SUNNINGDALE PARISH COUNCIL

21/00767 – Oakwood Broomfield Park Sunningdale Ascot SL5 0JS

Part single, part two storey side extension with ground floor front bay window and alterations to fenestration

The Parish Council reviewed this application on the 23 March 2021 and has several concerns about this application.

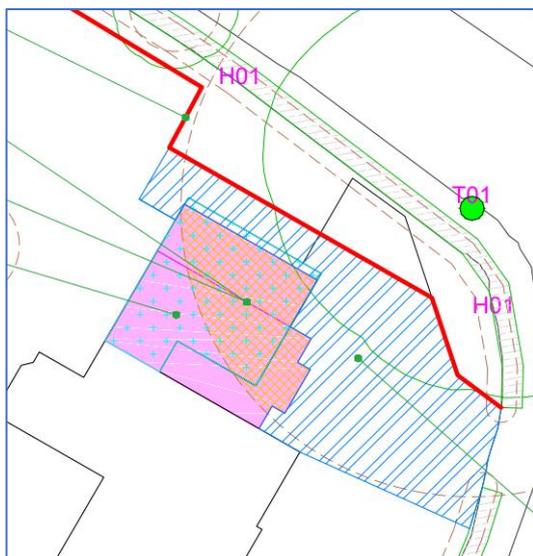
1. Piling into the roots

Hence, it is evident that the planned building extension requires excavations within the oak tree RPA to determine where the piles will be located and furthermore these trial excavations must somehow avoid significant roots.

Despite the detailed methodology described to ensure compliance the Parish Council are unsure how excavation would continue if a root of say 27mm diameter was in a critical position for the proposed foundations.

Differentiating significant roots from not significant roots for example based on their diameter and the realistic and effective management of such operations on site is unlikely to be straightforward.

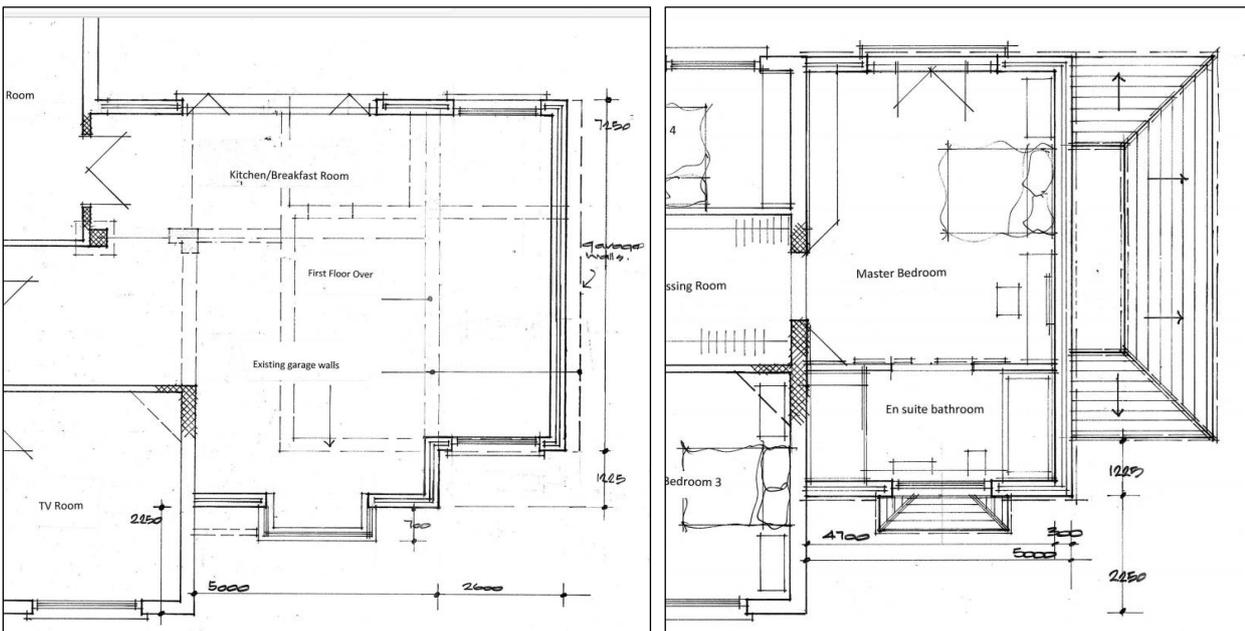
The applicant does not include a photograph of the oak tree which is unfortunate. A photograph taken in March 2021 from Broomfield Park road can be seen below. Even without any leaves it is readily apparent that this is a fine mature specimen oak tree that is in full public view, on its own and within the verge area and off site of the Oakwood property.

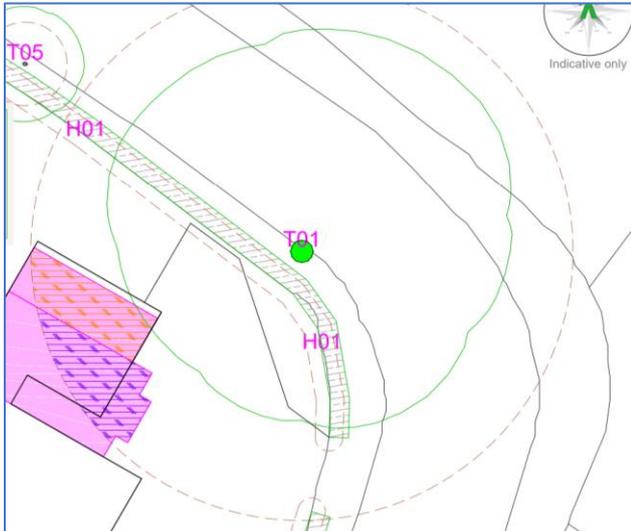
The diagram below submitted with the application clearly shows the impact of the proposed extension on the RPA of the tree. Also, the dotted circular line indicating the tree canopy shows that this extends to a significant degree over the new extension which is likely to lead to future pressure to prune the tree. We would ask for the Tree Officers comments especially as the radius shown for the RPA would appear to be a much shorter length from the oak tree trunk to Oakwood house than it is drawn in the opposite direction.
